# Addendum No. 06

April 11, 2024

## BAKERSFIELD COLLEGE STUDENT HOUSING (for DSA Project Name - New Residence Hall)

**PBK PROJECT NO.:** S2103400AR  
**DSA FILE NO.:** 15-C1  
**DSA APPLICATION NO.:** 02-122124

**T1.11A**

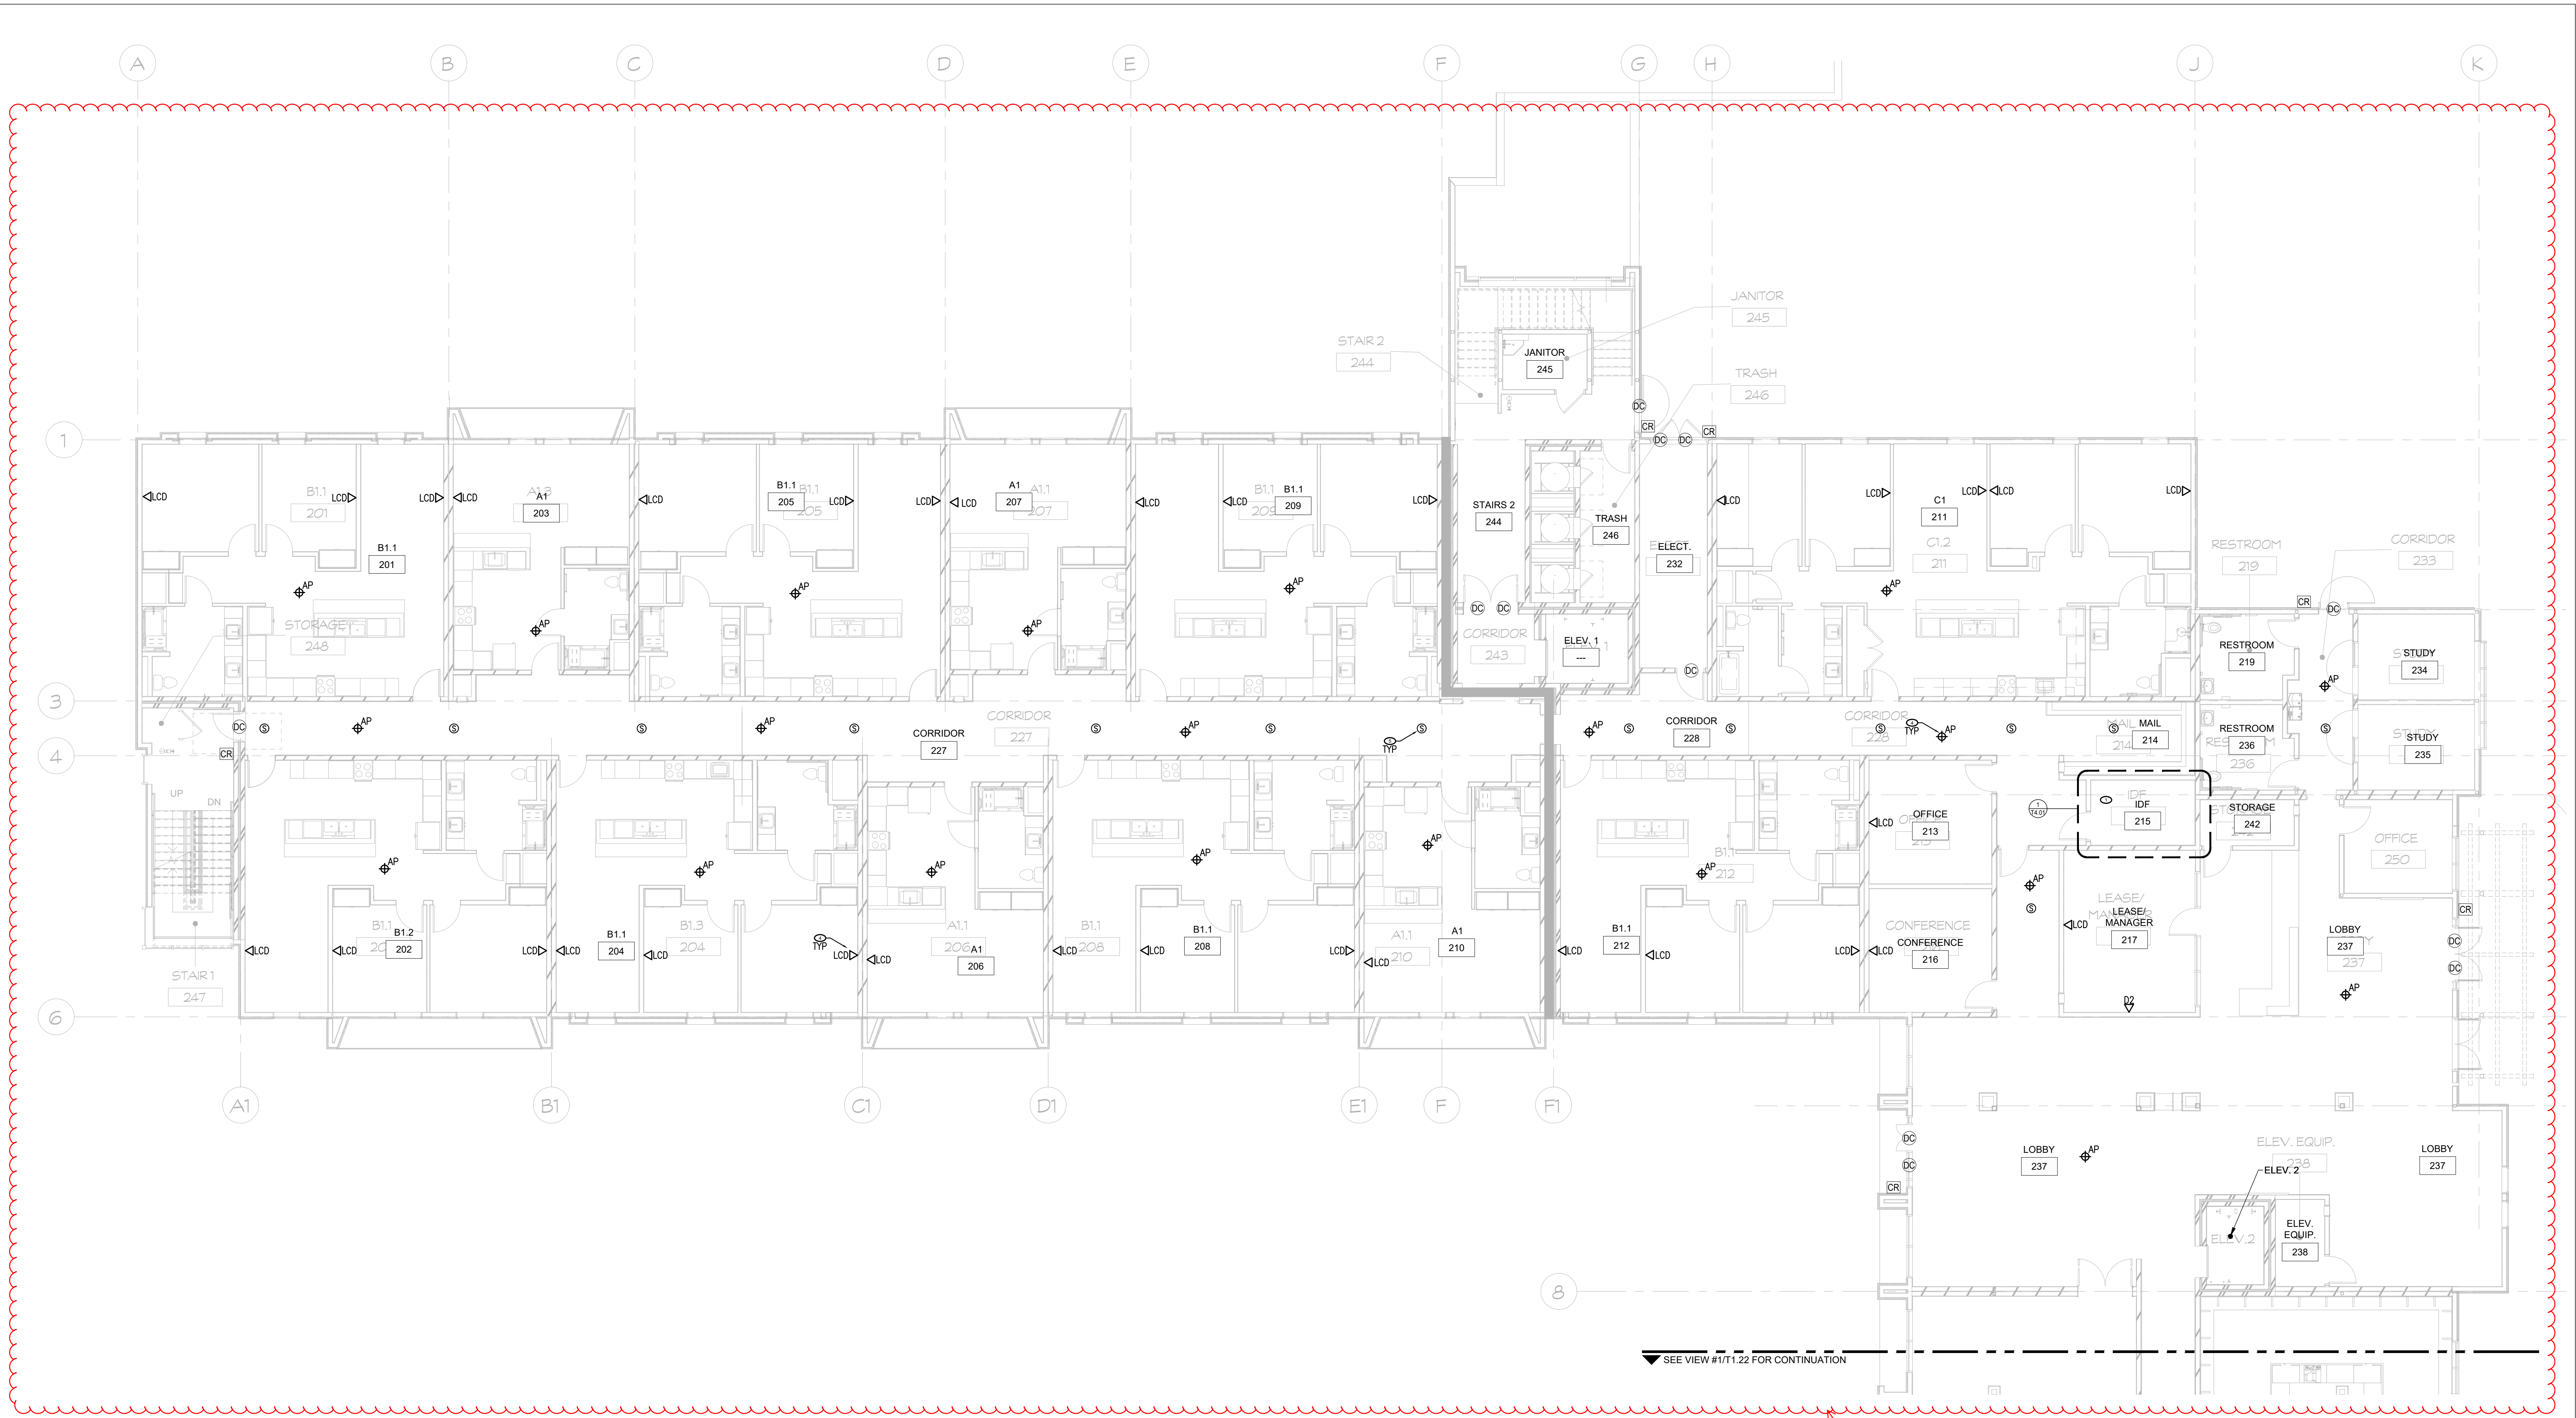
**AD6-57 T1.11, T1.11A, T1.21, T1.22, T1.31, T1.32, T1.41, T1.42 – TECHNOLOGY SHEETS** the technology sheets have been updated to remove D2 data drops in each room and to remove alarm motion sensors from the entry and corridor areas.
